INDEPENDENT REVIEW OF FLOOD MODELLING

Pacific Highway, Woolgoolga to Ballina
upgrade

Final report

JULY 2012

Figure 28: Schematisation error for Emigrant Creek

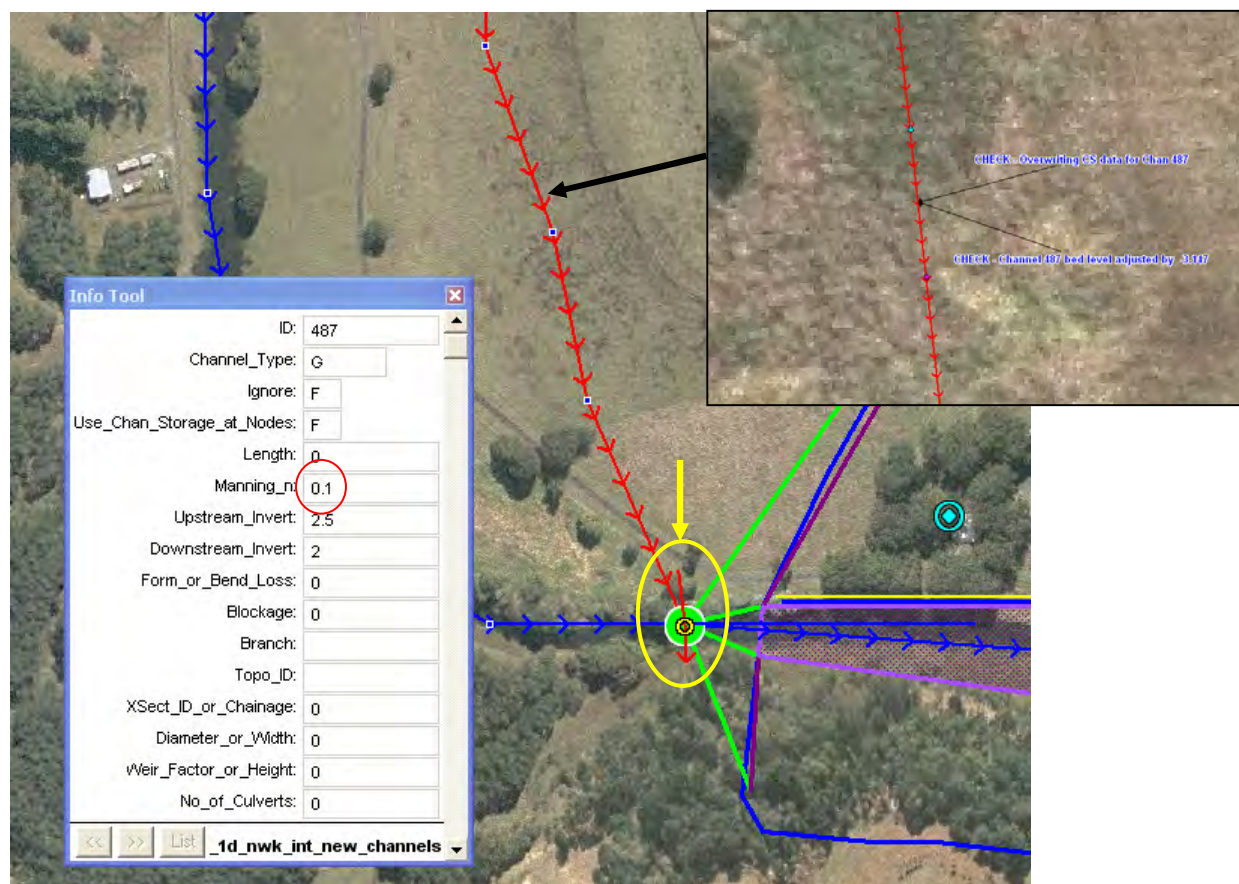
WMAwater identified that the cross section “EC0001.csv” was incorrectly snapped to the downstream node of Channel “487” (located at the upstream reaches of Emigrant Creek). There are two implications for this error, both of which are shown in Figure 28. Firstly, as Manning’s “n” roughness values were defined in this particular cross section, the Mannings_n attribute in the 1d_nwk layer becomes a multiplier and the resulting roughness value for this

channel becomes $0.1 \times 0.07 = 0.007$, which is applicable only to excessively smooth surfaces. Secondly, referring to the figure inset, this cross section (with a width of 54 m) was also incorrectly assigned to the red 1d_nwk polyline which represented the flow path along the adjacent floodplain. The original floodplain cross section with a width of up to 350 m was overwritten, hence this led to an underestimation of the floodplain storage available for this section of the creek.

Figure 29: Impacts above 60 mm for the 20 year ARI event

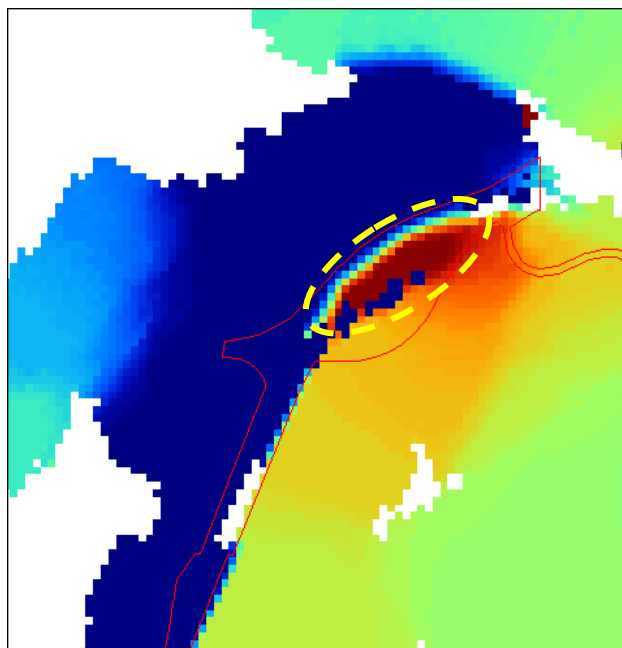
When examining the flood impacts caused by the proposed works within the lower Richmond River floodplain, afflux of more than 60 mm was exhibited on the east side of the Pacific Highway based on the 20 year ARI results grids provided to WMAwater, as illustrated in Figure 29. This impact, however, was found within the project boundary (demarcated by the red polylines in the figure) and hence is not of concern.

Figure 31: SOBEK model results for the Richmond River floodplain near Woodburn/Tuckombil Canal

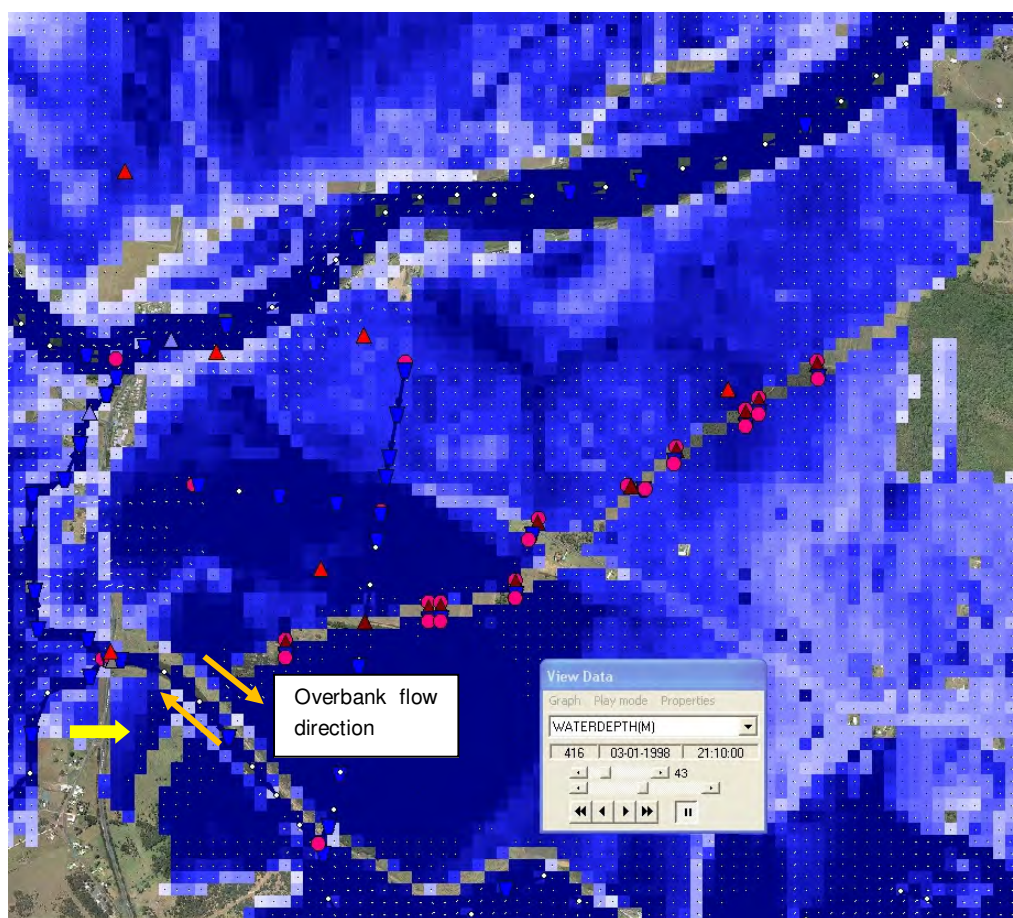
WMAwater postulate that reducing the bridge span over the southern floodplains of Tuckombil Canal in the SOBEK model would have minimal impact on the afflux in the floodplain as the model predicted that this floodplain (bounded by the existing Pacific Highway and Tuckombil Canal, indicated by the yellow arrow in Figure 31) will be filled by backwater from downstream of the Canal/proposed highway embankment. This was replaced by 2 box culverts in the TUFLOW model which serve largely to accommodate the backwater flow and to utilise the available storage at the location.
